Frankfort Castle

Dundrum, Dublin 14

Statement of Response
June 2021

RESPONSE TO ISSUES RAISED BY ABP

Context Elevation 01

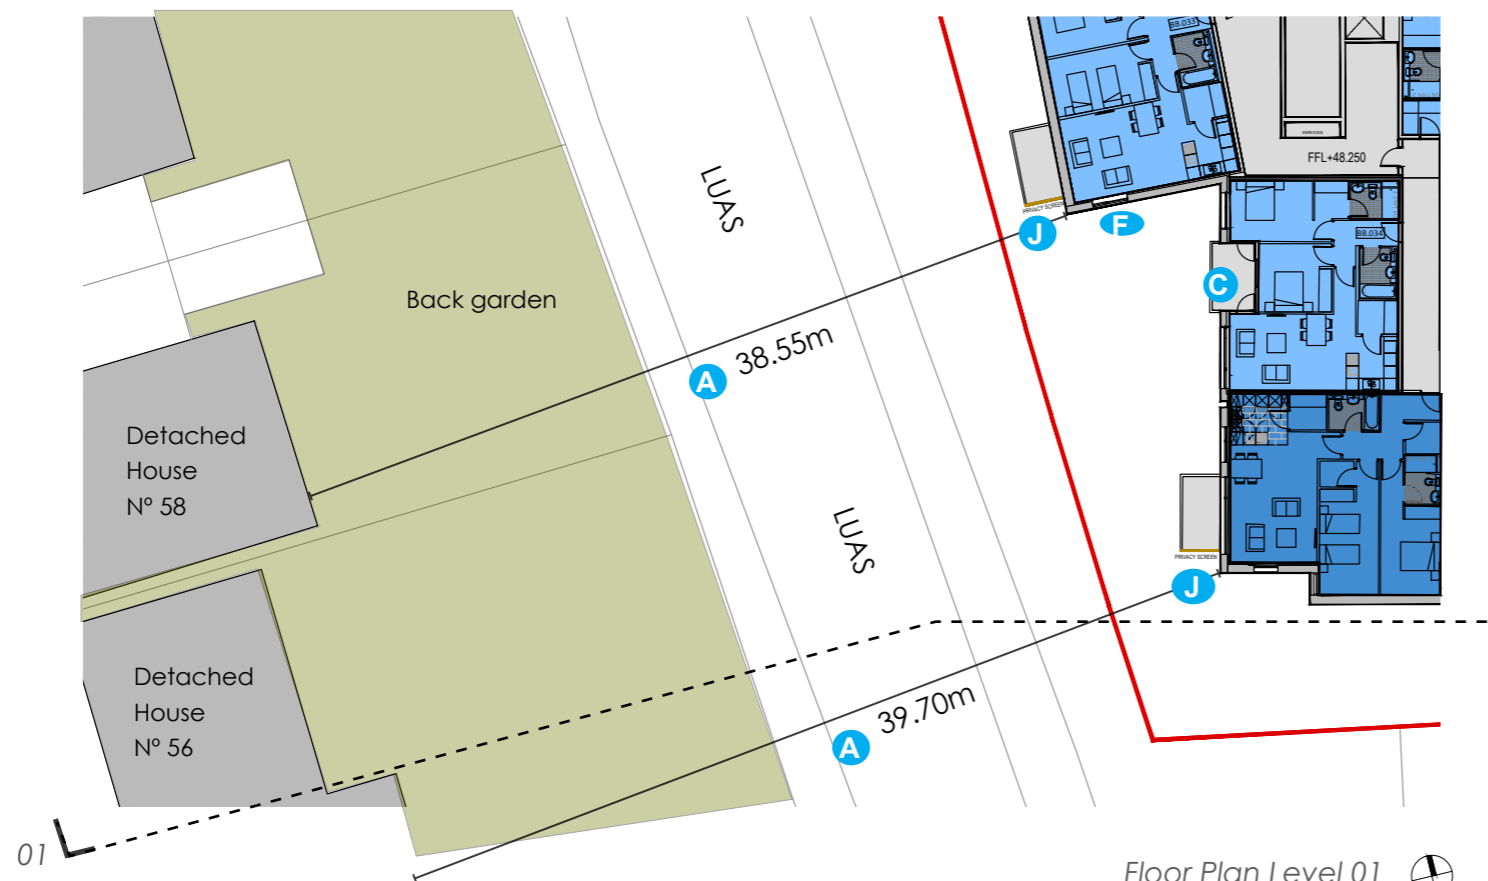
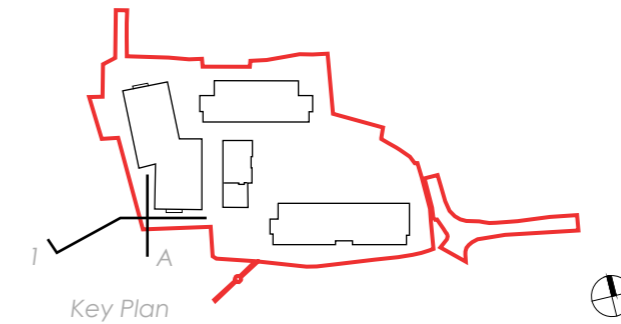
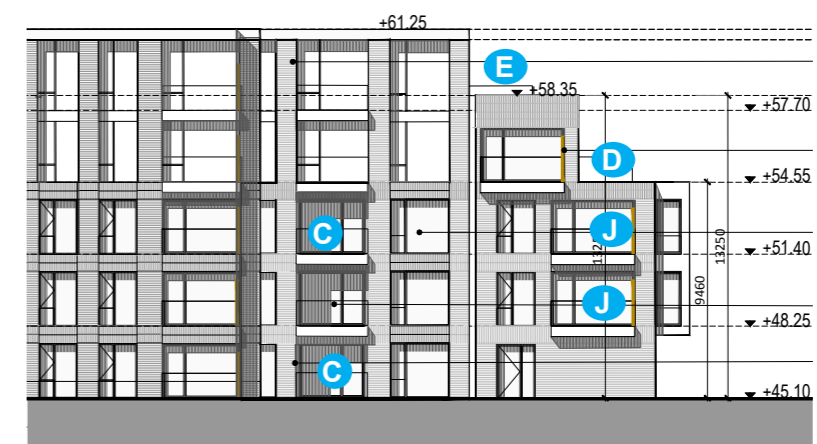
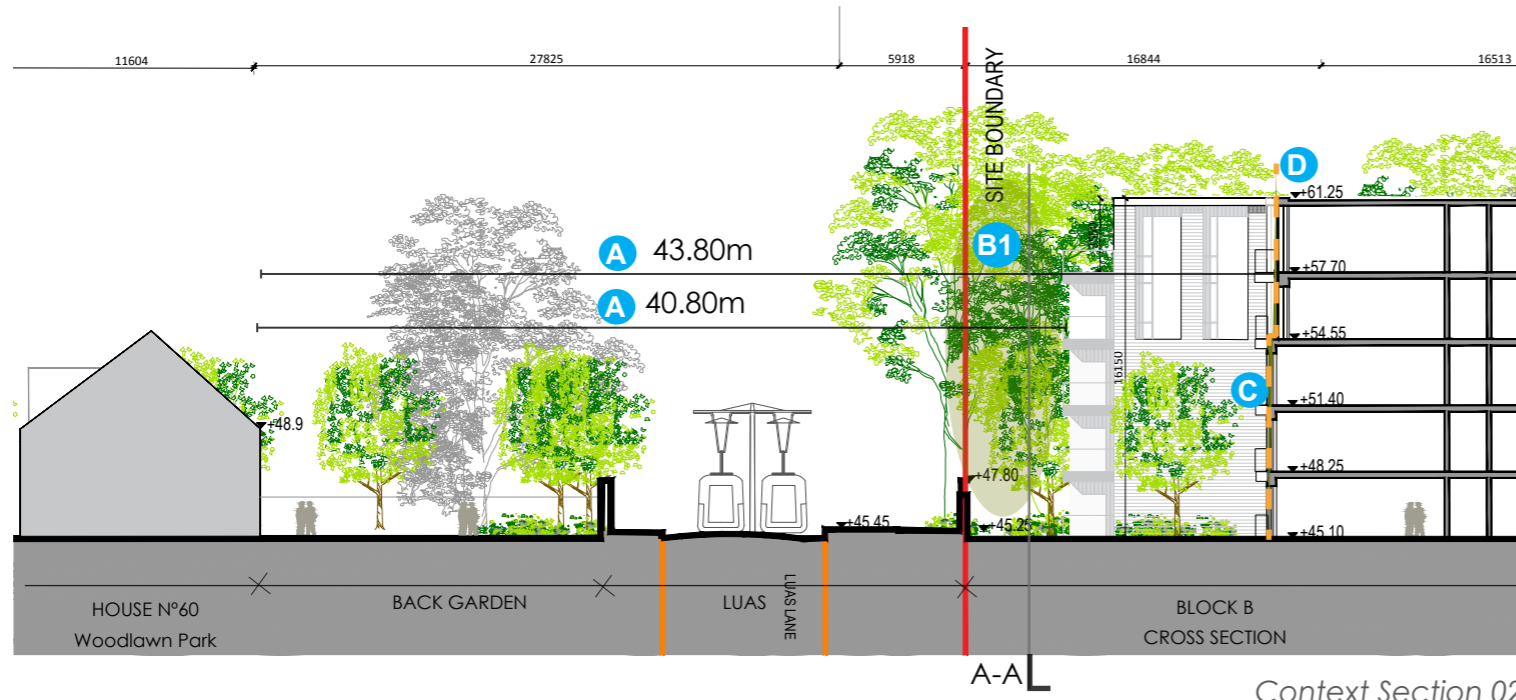
Mitigation/changes that are included to deal with potential overlooking of Block B westward elevation through Houses No. 52-64:

- A** • Separation Distance to the houses are between 38-42m
- C** • Inset balcony to increase the distance to the back gardens and reduce the vision angle.
- D** • Recessed terrace / steeped old profile to increase the separation distance at the top floors.
- E** • Inaccessible roof areas at the penthouse level
- J** • Privacy screens at the projected balconies on the edges to reduce the vision angle

Context Section 02

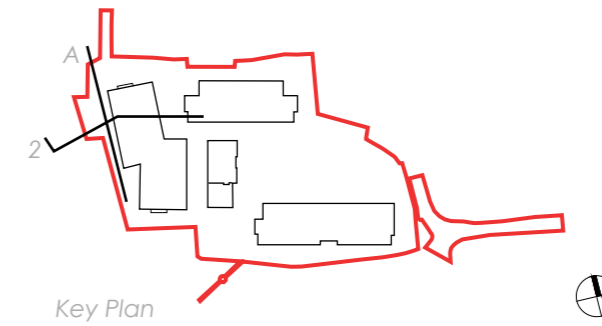
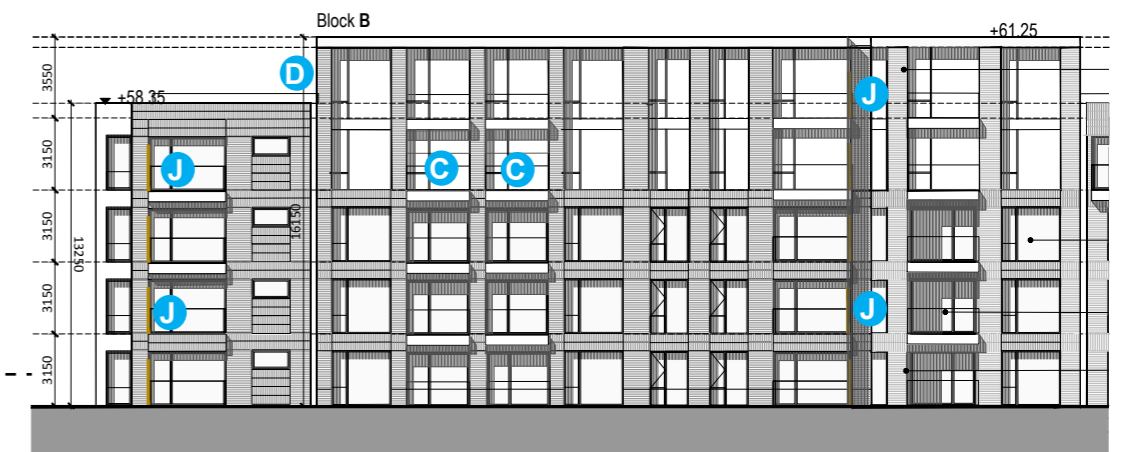
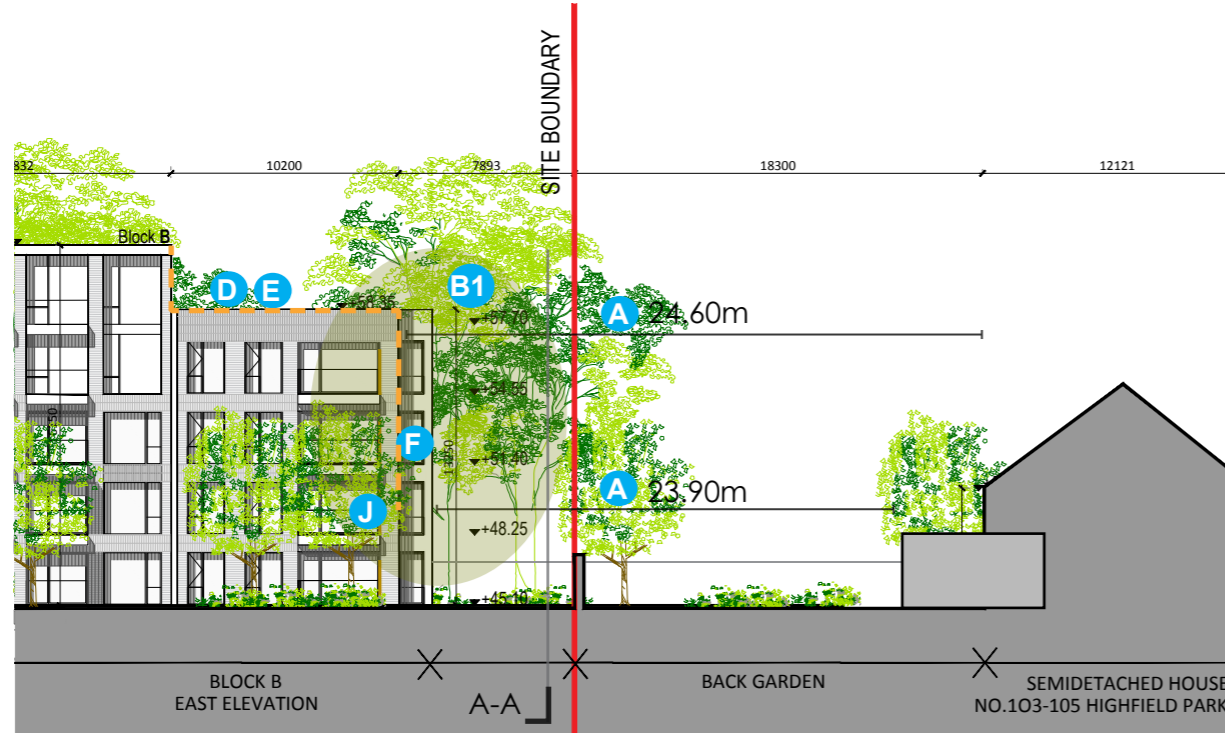
Mitigation/changes that are included to deal with potential overlooking of Block B Block B westward section through House N° 60

- A** • The separation distances to the houses are between 40-43.80 m
- B1** • The retained trees stand between the proposed scheme and the existing houses create a natural privacy screen .
- C** • There are Inset balconies proposed in to the middle units to increase the distance to the back gardens and reduce the vision angle.
- J** • Also for the corner units and the projected balconies there are privacy screens proposed to avoid the overlooking to the adjacent properties
- D** • Recessed terrace / steeped old profile to increase the separation distance at the top floors.

Context Elevation 03

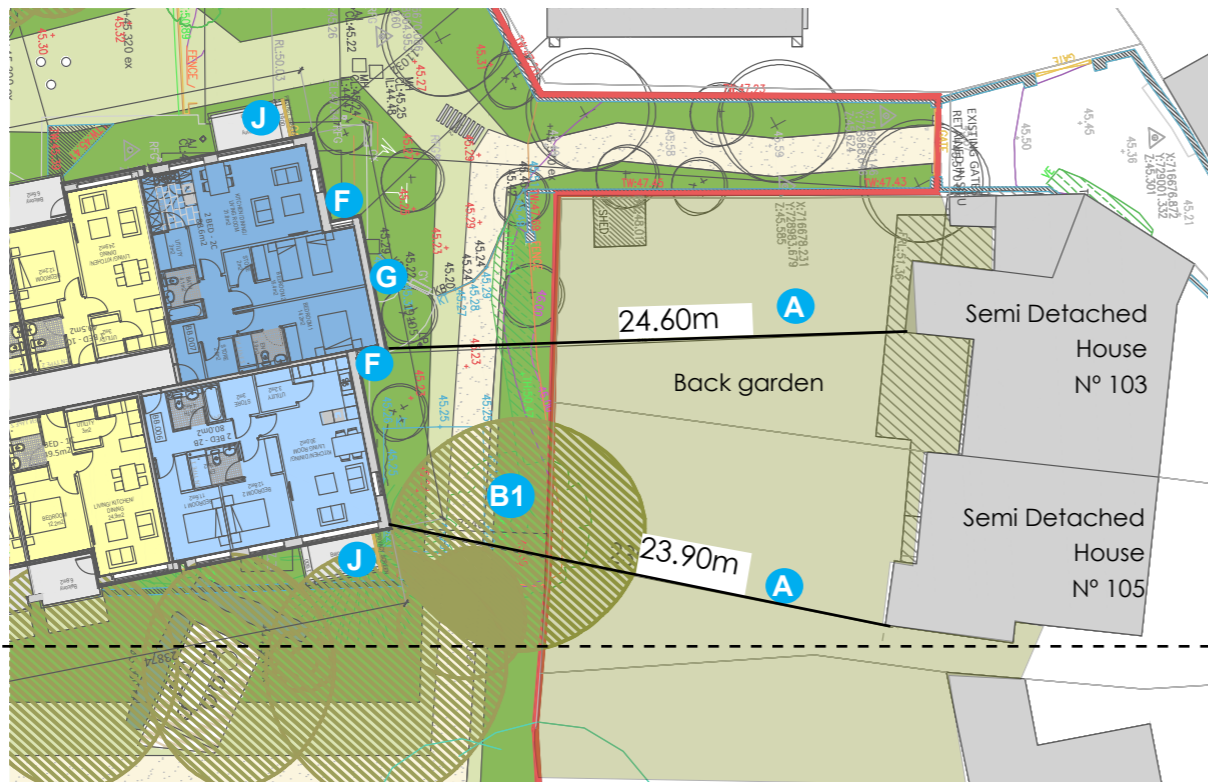
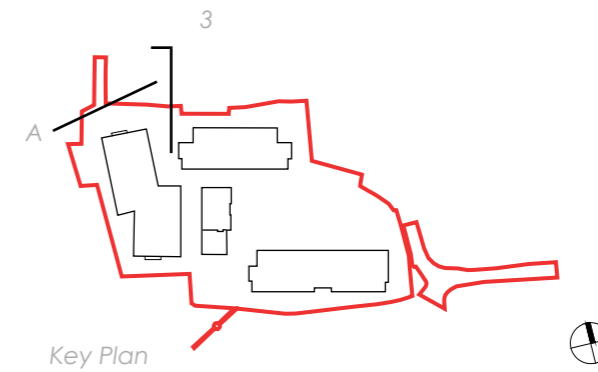
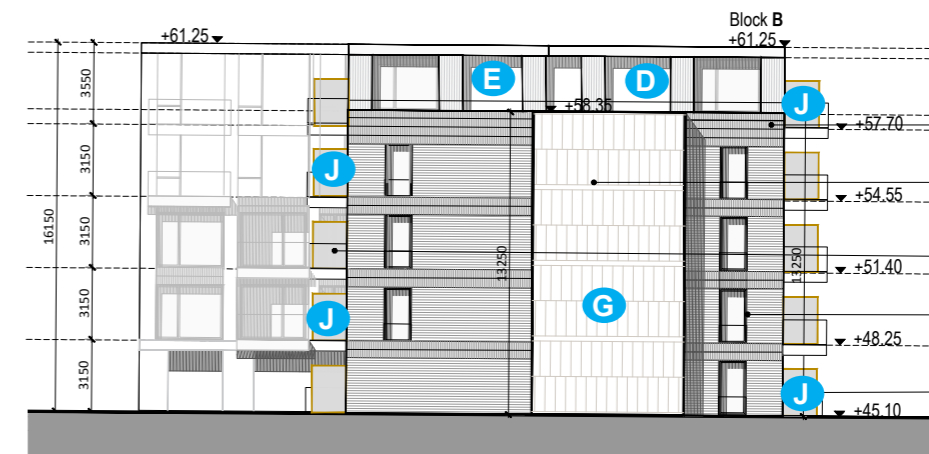
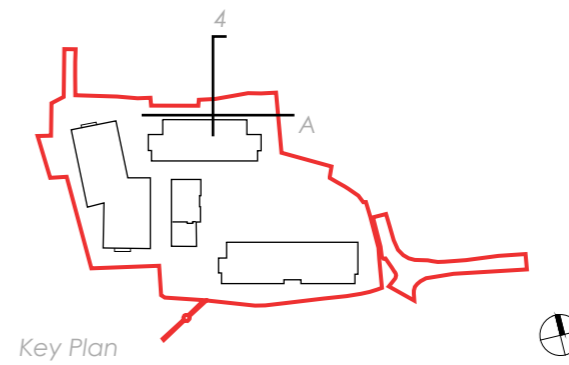
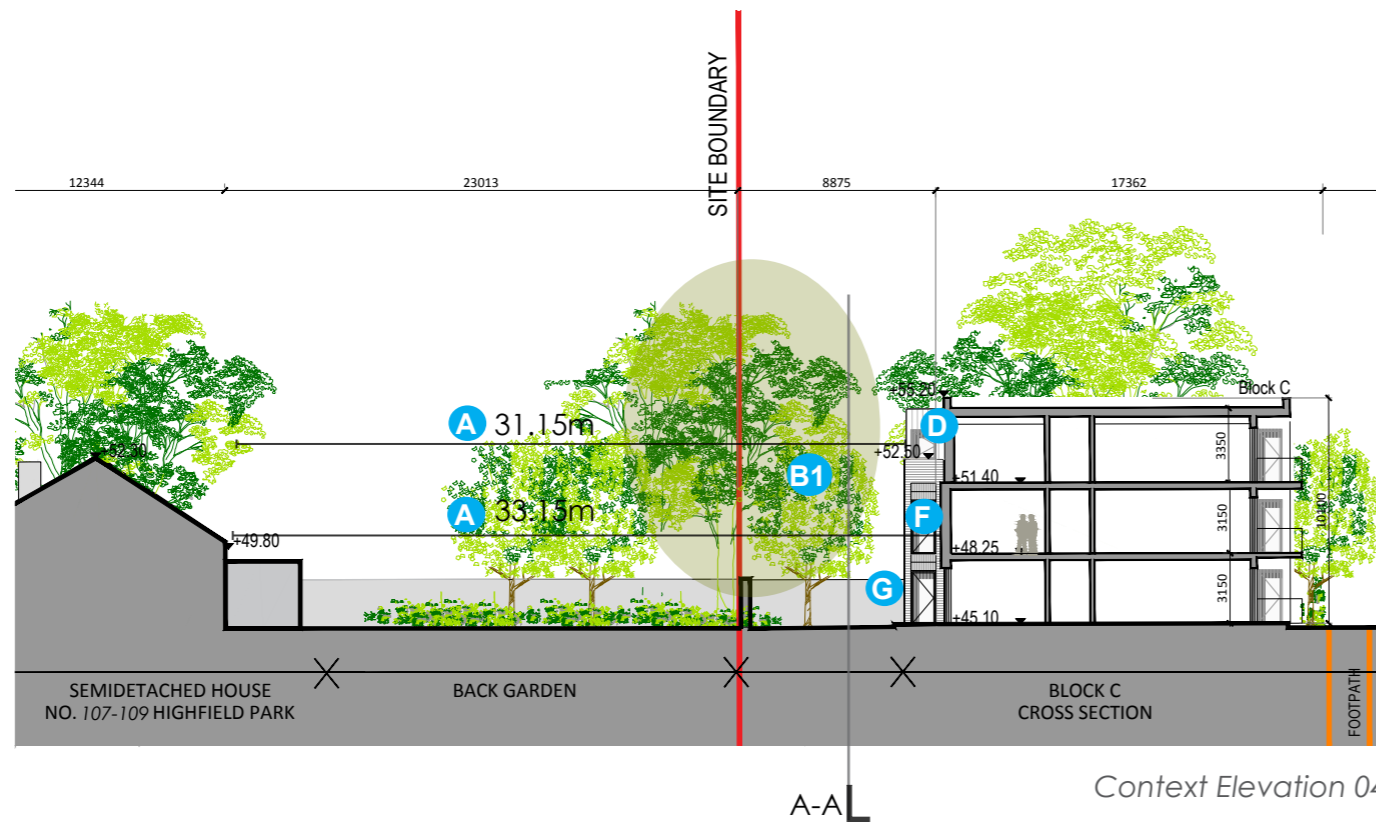
Mitigation/changes that are included to deal with potential overlooking of Block B North-Eastward elevation towards semidetached House no. 103-105 Highfield Park

- A** • The separation distances to the houses are circa 23-24m
- B1** • The retained trees stand between the proposed scheme and the existing houses create a natural privacy screen .
- J** • There are proposed privacy screens to avoid the overlooking to the adjacent properties on the projected corner balconies
- D** • Recessed terrace / steeped old profile to increase the separation distance at the top floors.
- E** • The roof areas are not accessible from the inner apartment units to avoid the overlooking.
- G** • The most exposed elevation area on the block B gable elevation is blanked to provide privacy to the neighbourhood properties

7.7 Context Elevations and Section 04

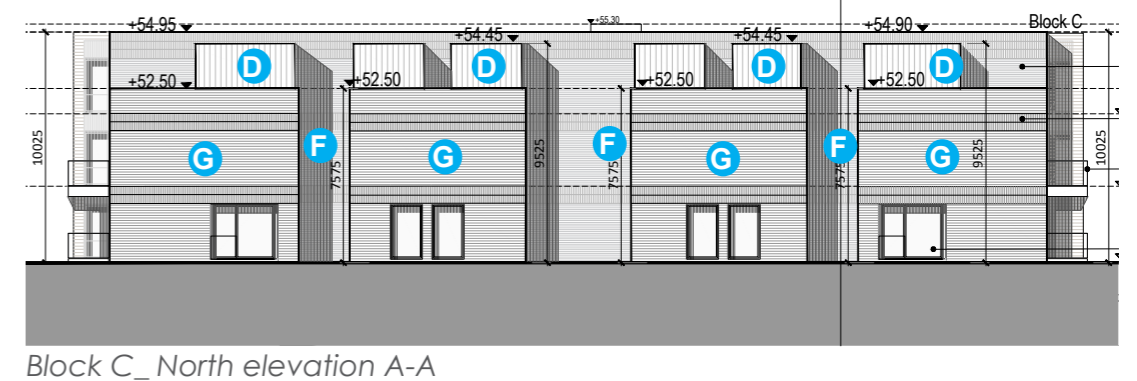
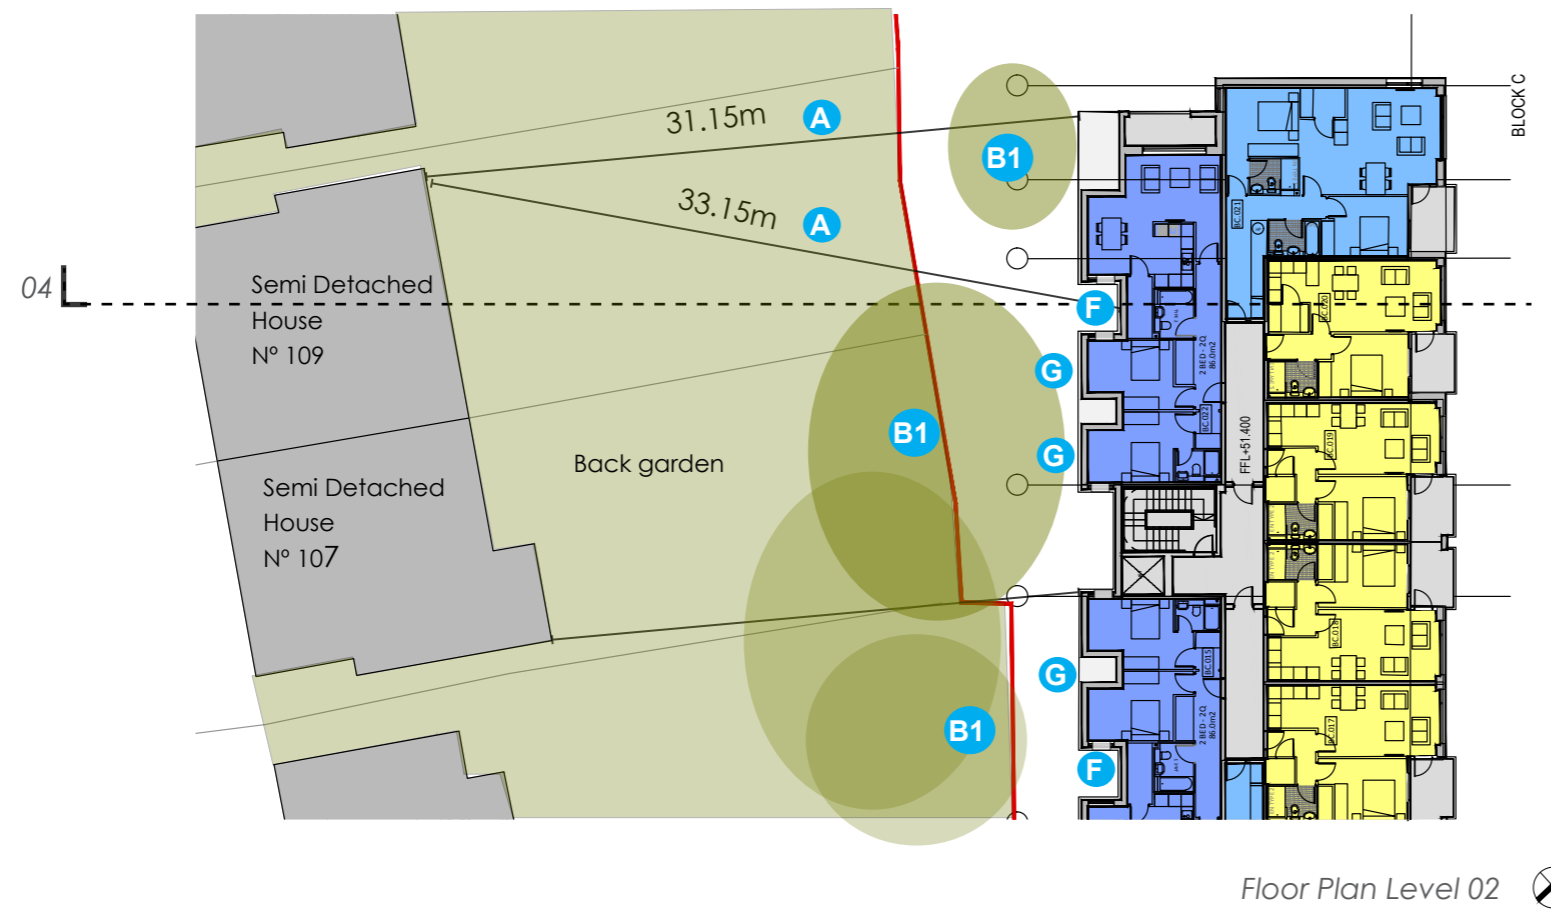
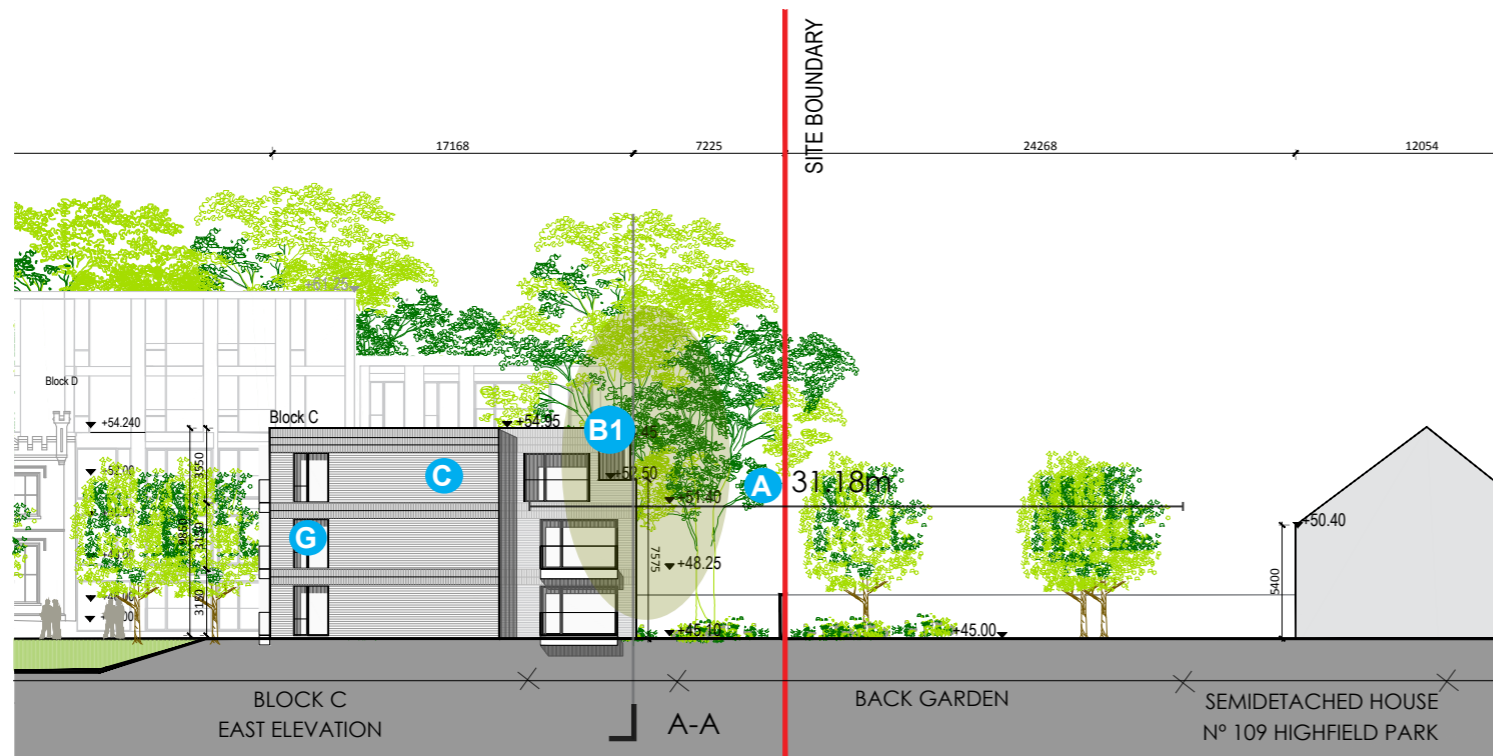
Mitigation/changes that are included to deal with potential overlooking of Block C eastward cross section through semidetached House no. 107-109 Highfield Park!

- A** • The separation distances to the houses are circa 31-33m
- B1** • The retained trees stand between the proposed scheme and the existing houses create a natural privacy screen .
- D** • Recessed terrace / stepped old profile to increase the separation distance at the top floors.
- F** • The directional windows are on level 1&2 at the north side of Block C.
- G** • The north elevation facade is blank at levels 1 & 2 to provide privacy to the adjacent neighborhood properties.
